AGENDA
PLANNING COMMISSION
116 WEST NEEDLES
BIXBY, OKLAHOMA
August 17, 2015 6:00 PM

BSP 2015-05 – “Jiffy Lube Office Building” – W Design, LLC (PUD 54)

1 PHOTOMETRIC SITE PLAN

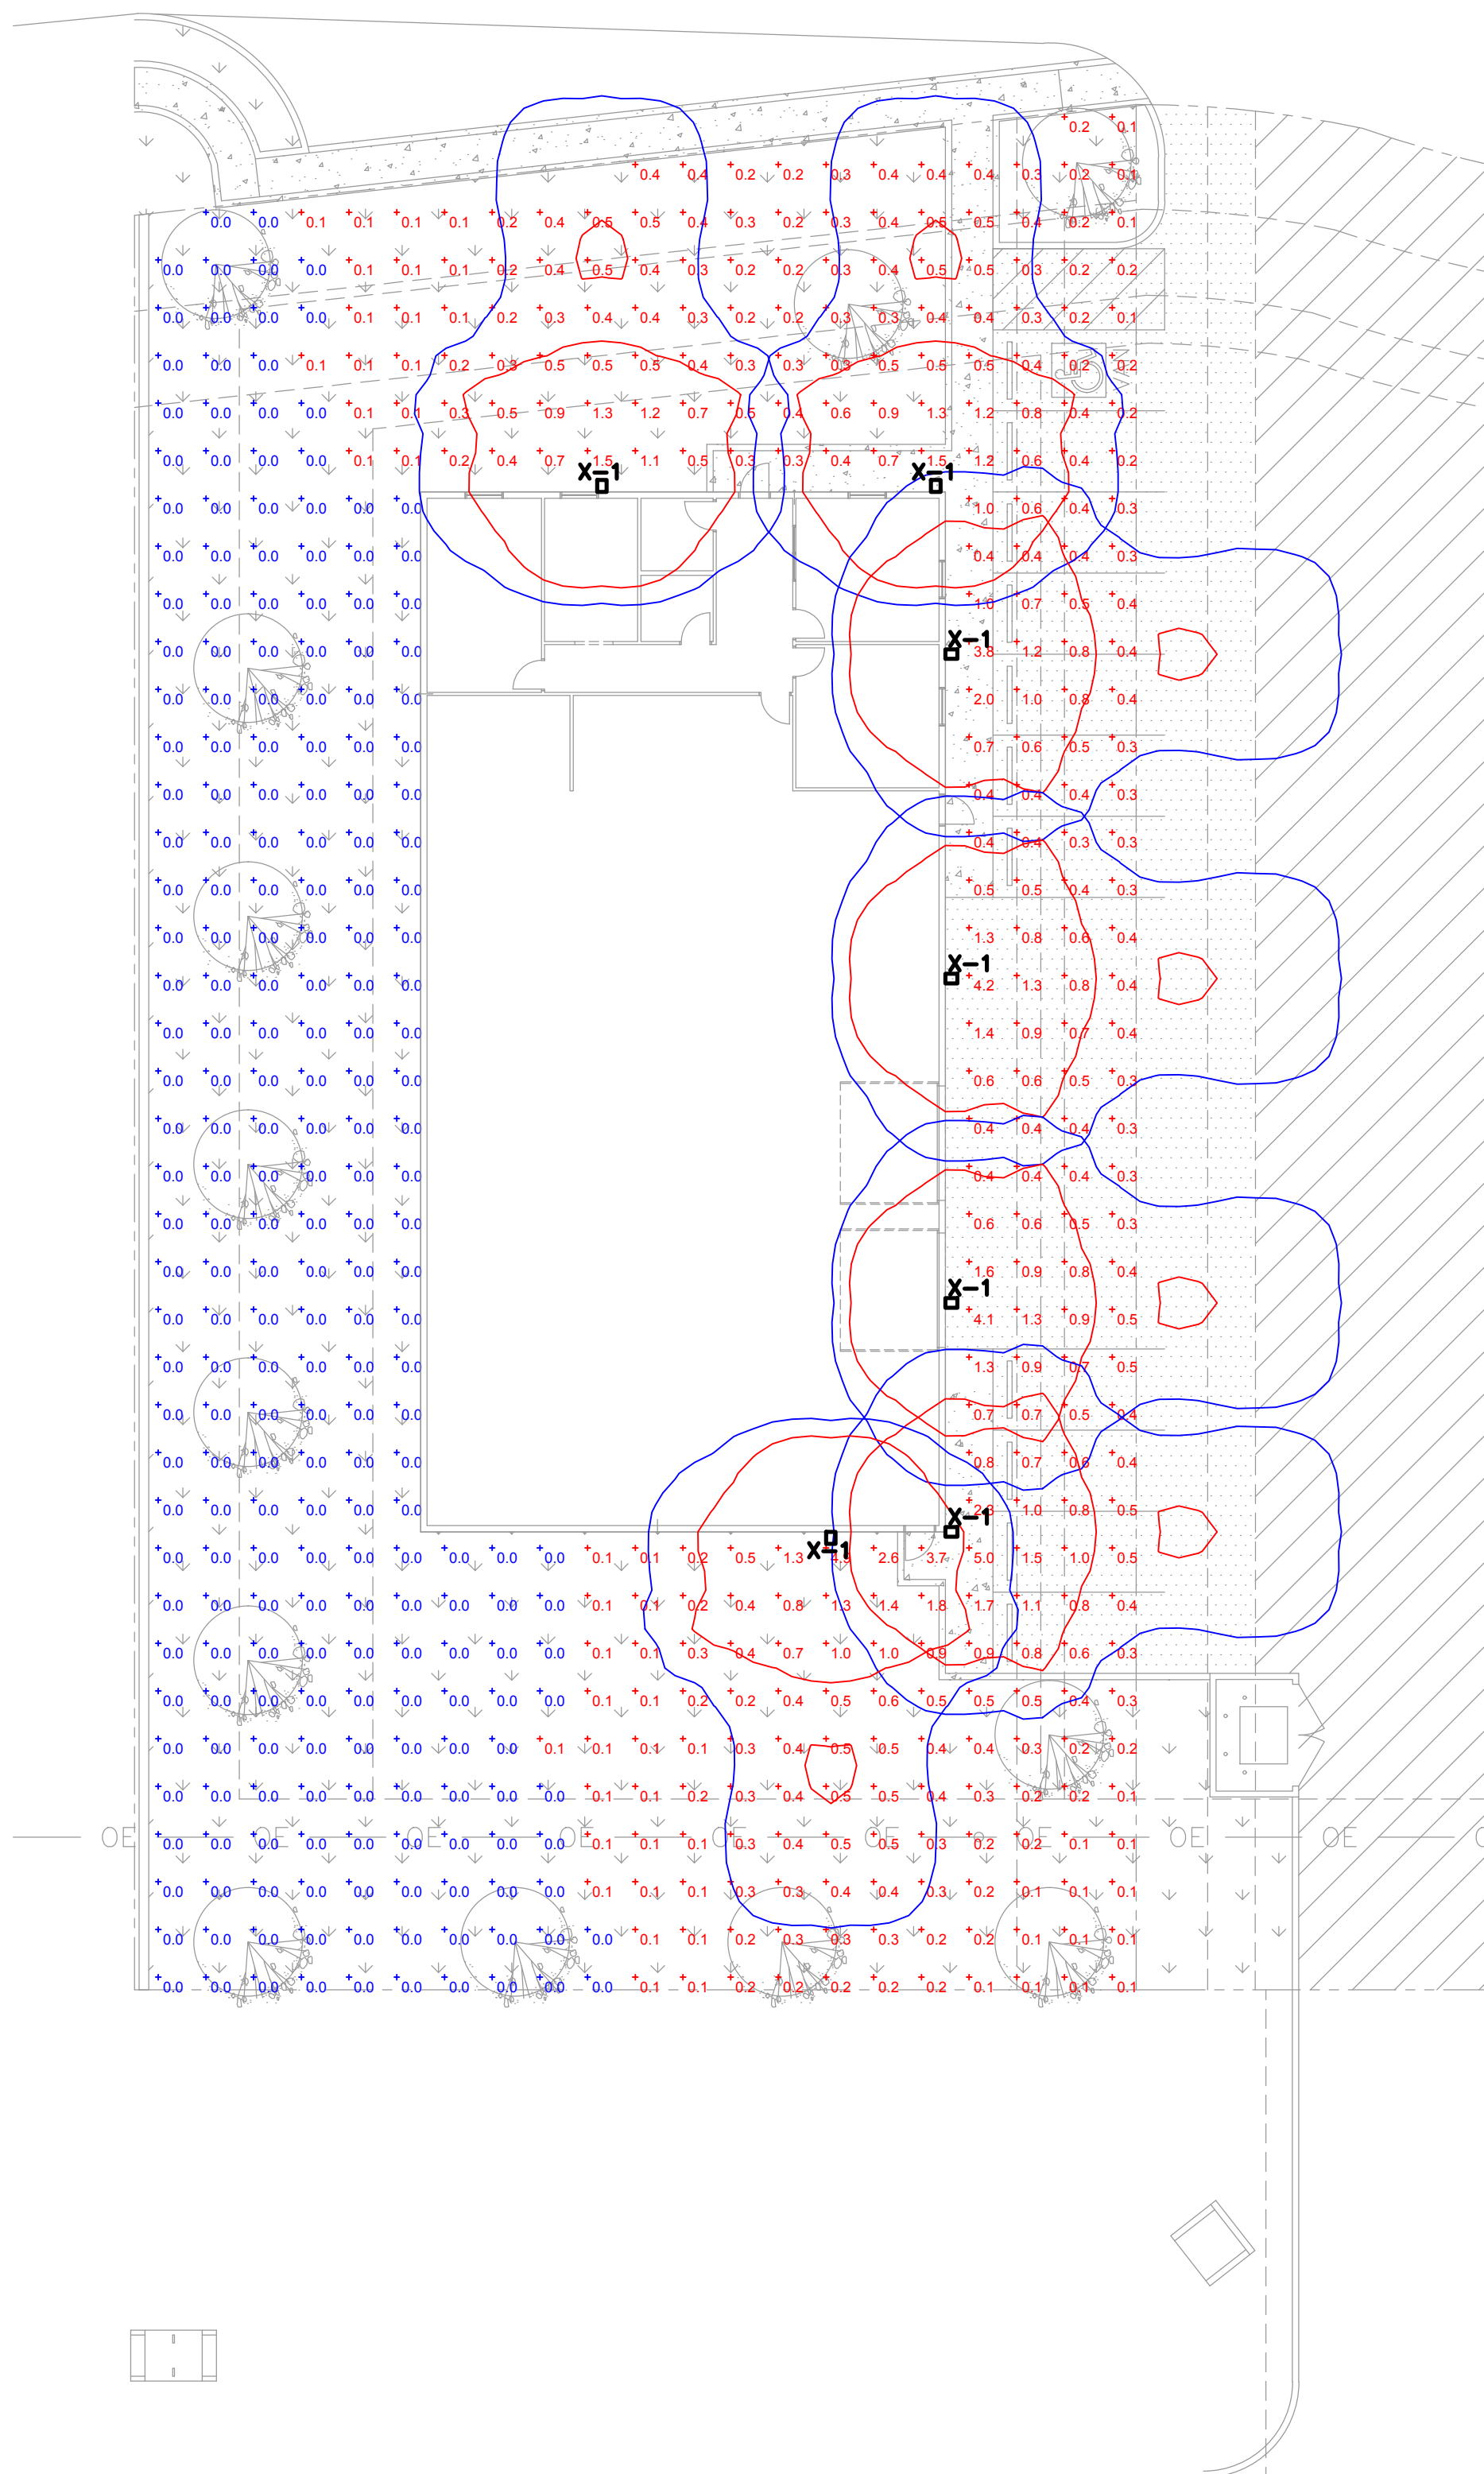
Outdoor Lighting. The Lighting Plan consists of “Photometric Site Plan” drawing AS102, which includes a photometric plan and a legend describing the different light fixtures proposed and certain other particulars. There do not appear to be any pole-mounted lights; all are building-mounted and appear typical for an office building application.
